SERVICE BULLETIN #2

Subject: Miscellaneous Technical Information for Dealer and Customer

SERVICE BULLETIN No.22

Subject: Engines with Load-Depending Injection Timing

F&SZWEIFACHKUPPLUNGEN

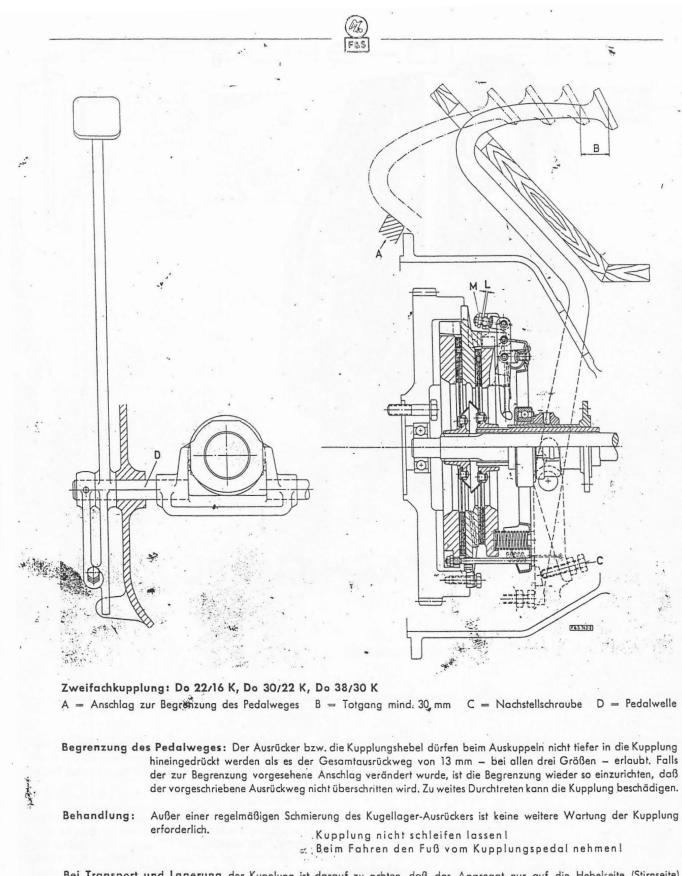
Nach Lösen der 6 Befestigungsschrauben kann die Zweifachkupplung geschlossen aus dem Schwungrad herausgehoben werden.

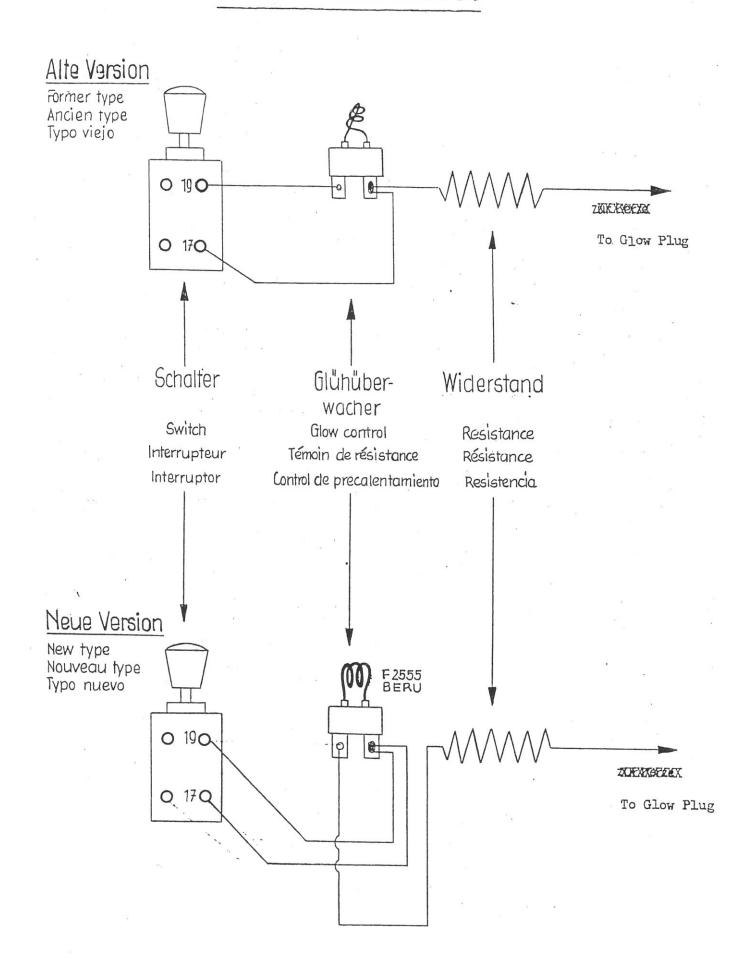
In addition to our service circular mentioned above we went to provide some exact installing instructions for the medication of the electrical wiring system at the glow control.

When removing the glow control you will find three wires:

one yellow-black wire (19) two black wires (17)

Try which one of the black wires develops sparks when brought into contact with yellow -black wire (19). This wire (17) is to be connected to the glow control as single wire, the other one together with yellow-black wire.

You may also determine the wires by means of a test lamp.

Connect one of the terminals of the lamp to the positive battery terminal, the other one to one of the black wires. The wire which causes the test lamp to light up is to be connected as single wire.

Be careful that the wires are not mixed up, since, in this case the glow control will remain out of the circuit and the glow plug will be overstressed.
